MONTGOMERY COUNTY DEPARTMENT OF PARK AND PLANNING

MEMORANDUM

SUBJECT: Staff Recommendations on the Commuter Bikeway and Bus Priority
Lanes in the Plans and Designs for the US 29 Interchange Projects

M-NCPPC recommended Commuter Bikeway alignment

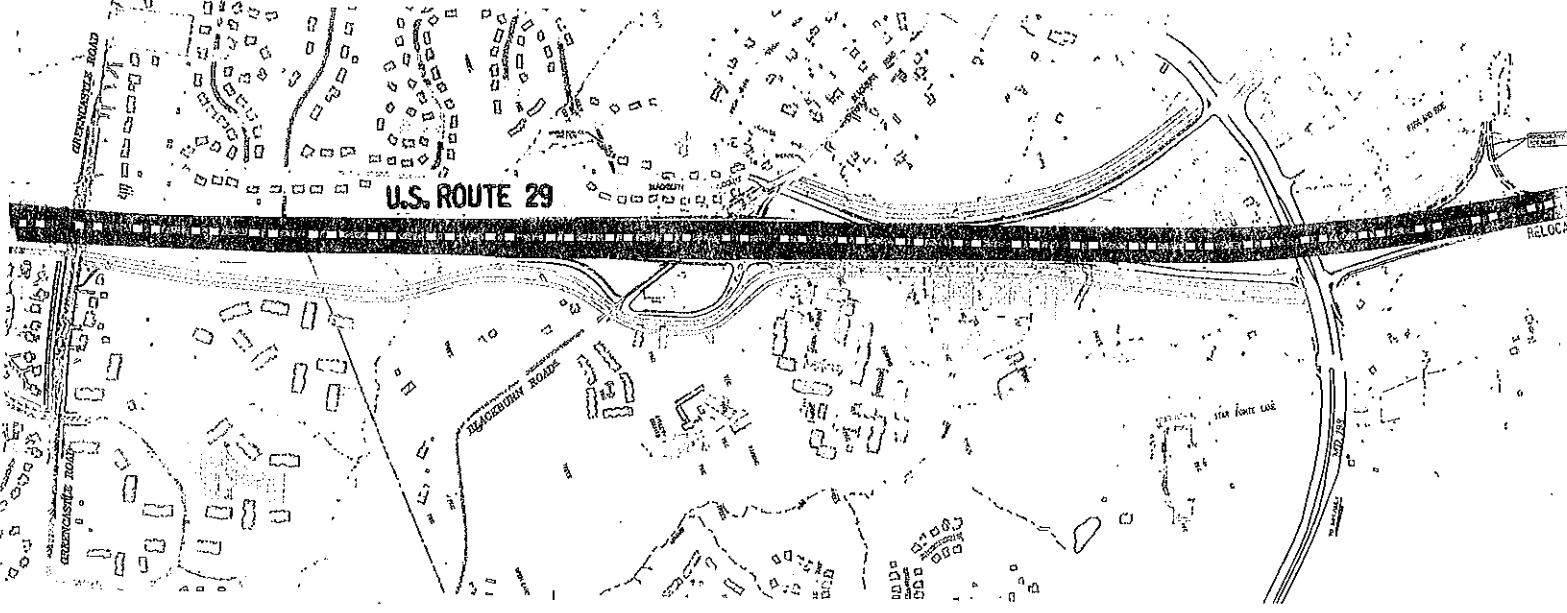
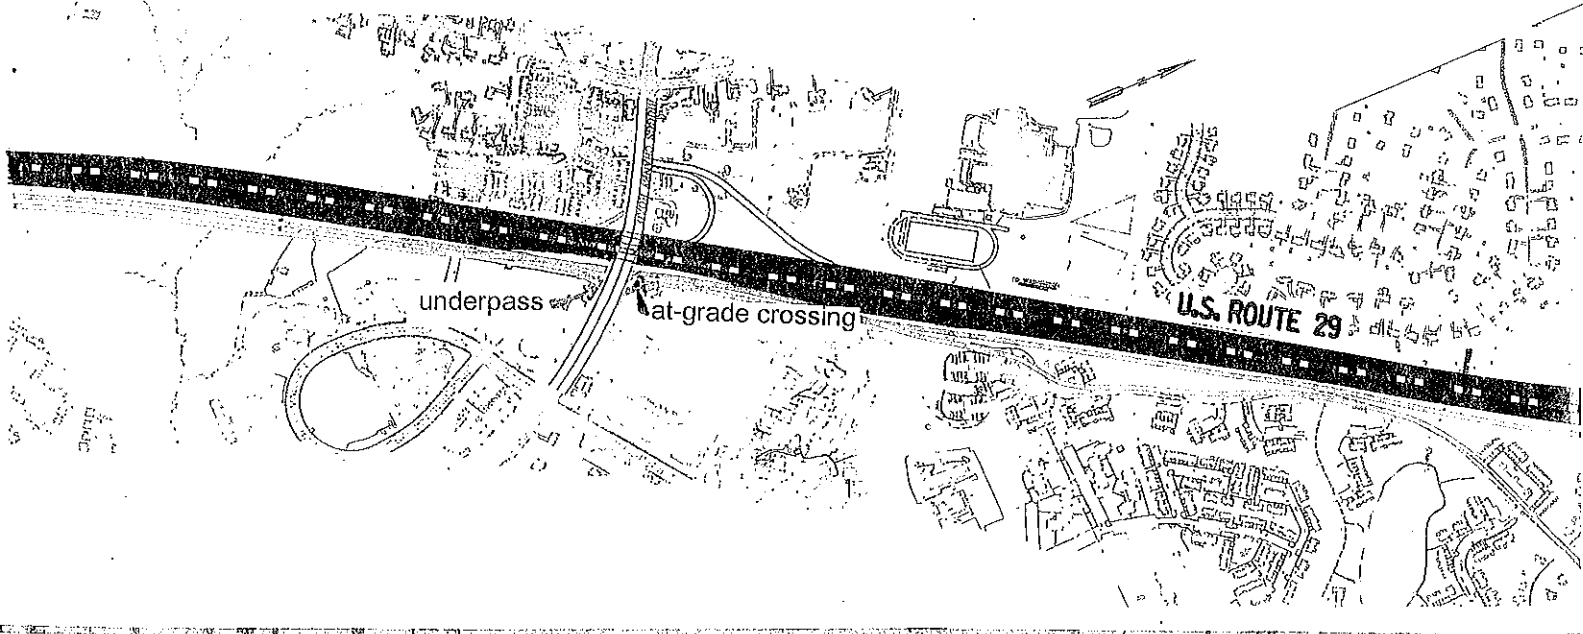
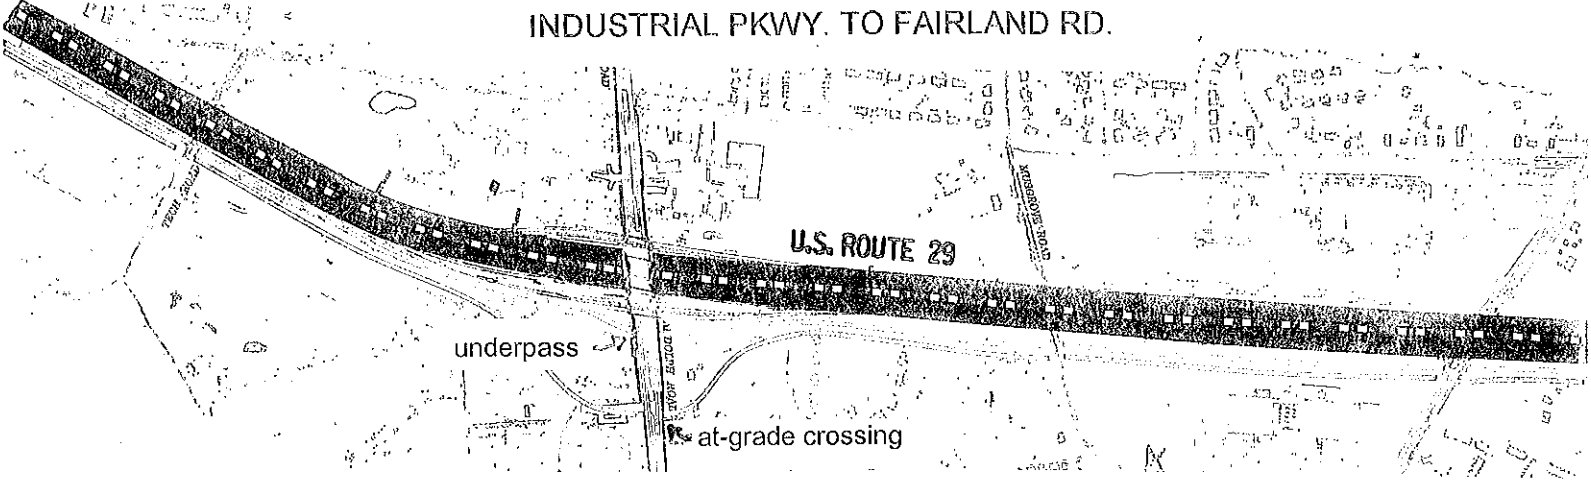
The difference between our staff's recommended Commuter Bikeway alignment and SHA's proposed alignment are shown in Attachment 2. Our staff has agreed with SHA's proposed alignment in most respects, except for some short segments and the treatment at the major cross-streets. SHA staff currently prefers to have at-grade crossings for the Commuter Bikeway at signalized intersections, whereas our staff prefers bikeway underpasses through the elevated sections of the interchanges, especially at Cherry Hill Road and at Briggs Chaney Road.

1. Construct a high-quality off-road, continuous, and community-friendly Commuter Bikeway between MD 198 and Industrial Parkway, parallel to and along the east side of US 29. The recommended alignment for the bikeway is shown on the map in Attachment 1.

ILLUSTRATIVE – US 29 & RANDOLPH ROAD

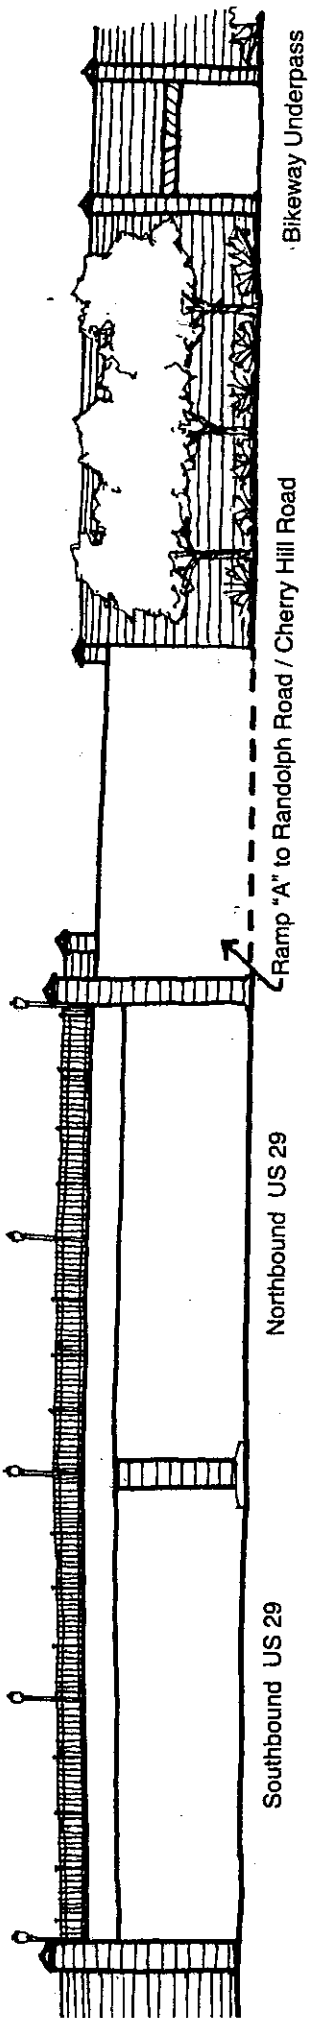
Staff would prefer to have grade separations at each of the cross-streets along the Commuter Bikeway, but is willing to recommend a compromise that would provide grade separations only at the most heavily traveled cross-streets. Staff agrees that at a minimum, underpasses for the Commuter Bikeway are warranted, at heavily traveled Briggs Chaney Road and at Cherry Hill Road. Since SHA already expects to rebuild those roads on fill to much higher elevations than they are today, underpasses at those locations would be easier to provide than they would otherwise be. A drawing of how a bikeway underpass at Cherry Hill Road could look is shown in Attachment 5.

2. Provide underpasses for the Commuter Bikeway at heavily traveled cross-streets in order to meet the Fairland Master Plan's objective of minimizing conflicts between bicyclists and vehicles at interchanges. At a minimum, install box culverts with rectangular openings of 12 feet x 10 feet for bikeway underpasses at the Randolph Road and Briggs Chaney Road interchanges.

**ZONES UNSUITABLE FOR BUS LANES
AFTER THIRD INTERCHANGE IS BUILT**

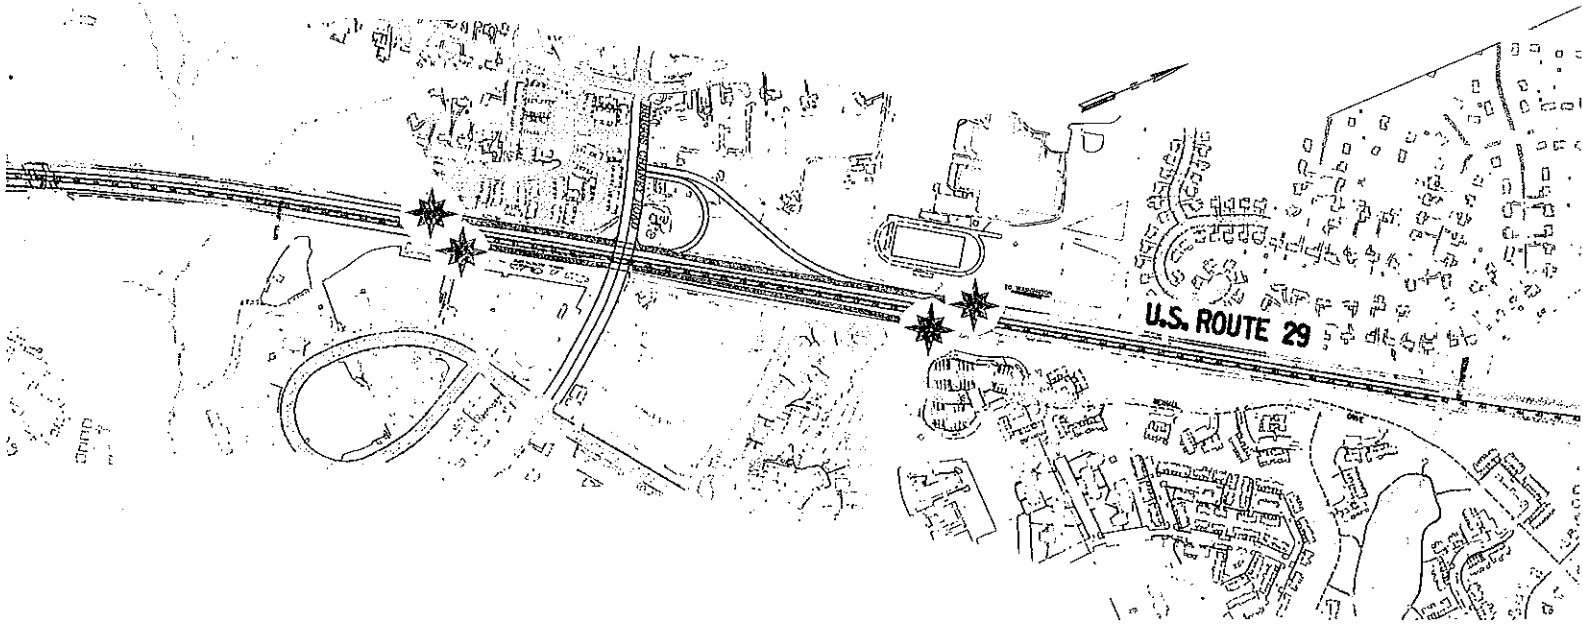
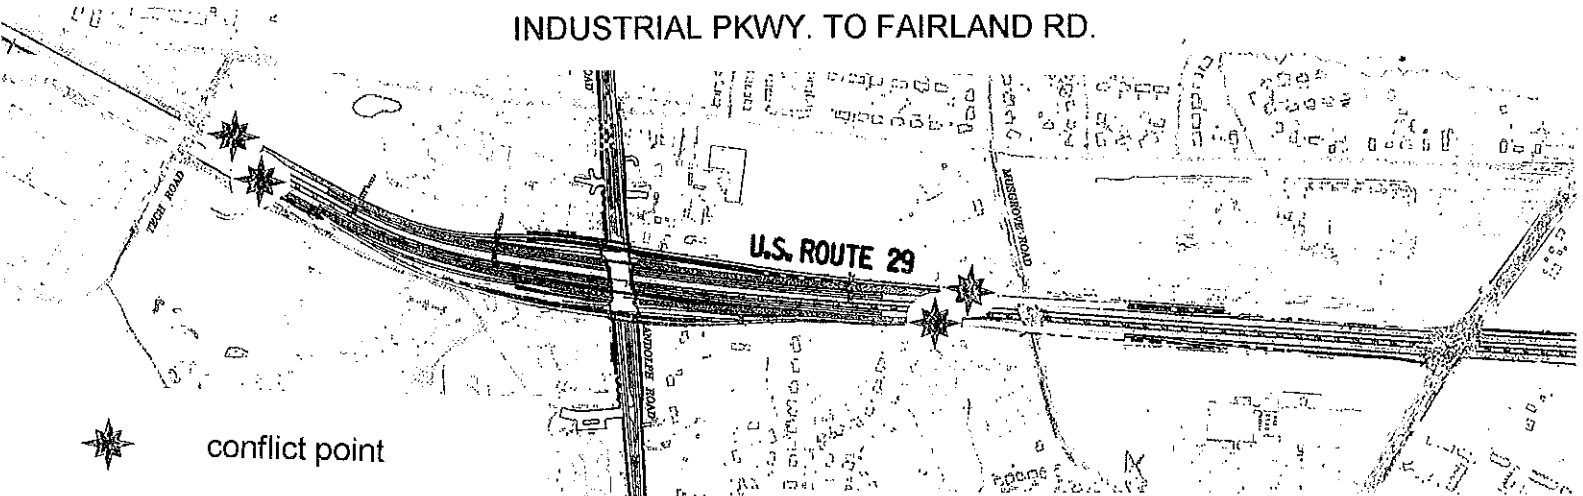
Although the bus lanes in the outside shoulder work fairly well now, as the new interchanges are built the buses will encounter more and more problems. This will be due to the narrowness of the lanes and potential conflicts whenever a bus has to cross acceleration and deceleration ramps at the new interchanges. Every time a bus approaches a ramp, the driver would need to slow down to a crawl and most likely stop until there is a gap in the flow of traffic on the ramp, and then proceed carefully through the interchange area. These repeated delays obviously defeat the purpose of giving buses priority in traffic. The problem will get worse as the number of interchanges on US 29 increases.

Staff recommends that the transition occur at the same time that the third of the first three interchanges is built. By that time, significant sections of the existing outside shoulders on US 29 would be interrupted by new ramps and weaving sections so as to make bus operations there slow and accident-prone. According to a recent consultant analysis, the optimum bus travel time savings would then occur in the inside shoulders. For the above reasons, our staff recommends that SHA fund a companion project for the third interchange (at Briggs Chaney Road), which would implement the remaining segments of the 12-foot-wide inside shoulders for the whole length of US 29 between Industrial Parkway and MD 198.

- 2. By the time of mandatory referral review for the Briggs Chaney Road interchange, prepare a schedule for shifting the bus priority lanes from the outside shoulders to the inside shoulders of US 29, between MD 198 and Industrial Parkway. Identify sufficient funds so that the remaining segments of the inside shoulders that are beyond the project limits of the funded interchange projects can be constructed at approximately the same time that the Briggs Chaney Road interchange is constructed. The entire length of the bus priority lanes in the inside shoulders should be available to buses by approximately the time construction of the Briggs Chaney Road interchange is completed.**
